Technical design note

Project name	This City - Rodney Street		
Design note title	Designer's Response to Stage 1 and Stage 2 Road Safety Audit		
Document reference	RODSTA-HYD-ZZ-00-RP-A-01006		
Author	C Peachey BA (Hons)		
Revision	1		
Date	27 July 2023	Approved	✓

STAGE 1 and 2 ROAD SAFETY AUDIT
Proposed Residential Development
Land to the West of Rodney Street
Ancoats
Manchester

Appendix A - Audit Key Plan

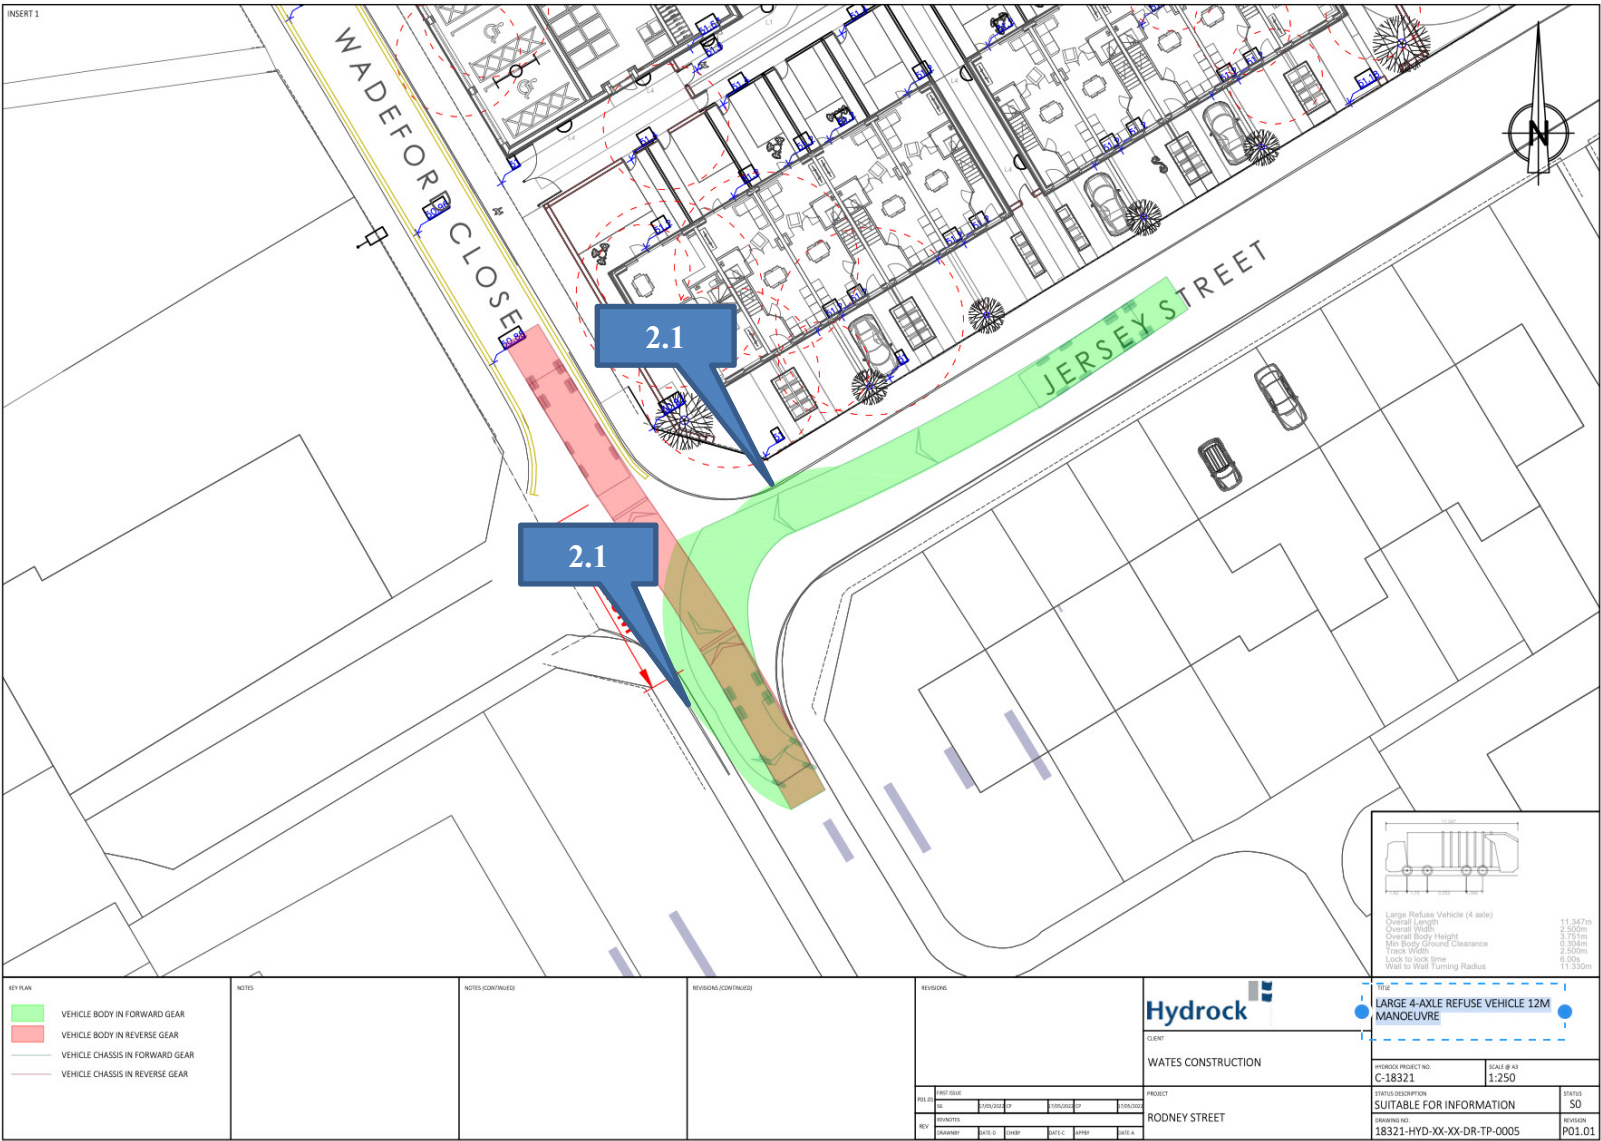
Location: Junction of Wadeford Close/Jersey Street

Summary: Overrunning vehicles could collide with pedestrians on the footway

Swept path analysis provided for a refuse vehicle at the junction of Wadeford Close/Jersey Street indicates a left turning refuse vehicle will overrun the footway on Jersey Street at two locations. This could lead to possible collisions with pedestrians using the footways.

Recommendation: It is recommended that appropriate road widths/radii are provided so this movement can be safely undertaken by refuse vehicles.

The swept path analysis has been updated to demonstrate that the refuse vehicle would not over run the footways, this is provided in Appendix B of this Designer's Response.
